Development Assessment

Subject: Item 3.3 - DA2024/0012 - 78 Grandview Drive, NEWPORT

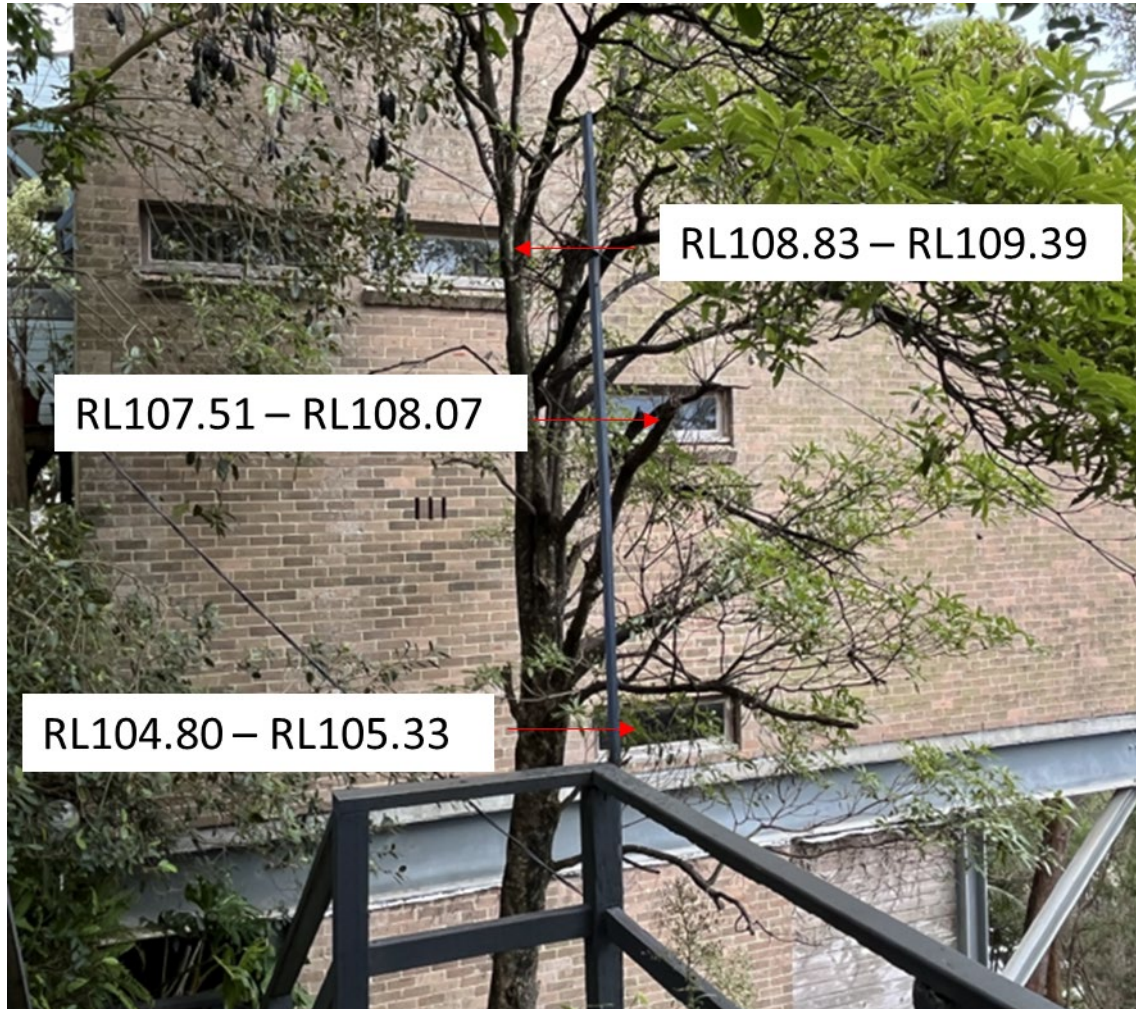
The windows referred to in the late submission above are shown in the image below:

An email from the residents of 80 Grandview Drive confirmed that the two windows to the upper left are from a living room and have a sill height of 1500mm.

The two windows in the centre of the image serve an internal staircase.

Privacy measures to prevent overlooking from the living room windows to the entranceway to the studio included a 1.8m privacy screen at the top of the staircase.

It is noted that the lower of the two internal staircase windows is located at RL104.80 and RL105.33 and the middle landing of the proposed staircase has a floor level of RL105.37.

However, given that both staircases are not considered to be highly trafficable areas and that the landing is 1.3m from the side boundary and approximately 2.6m from the internal staircase windows of 80 Grandview Drive, it was not considered that the stated privacy concerns warranted a redesign.
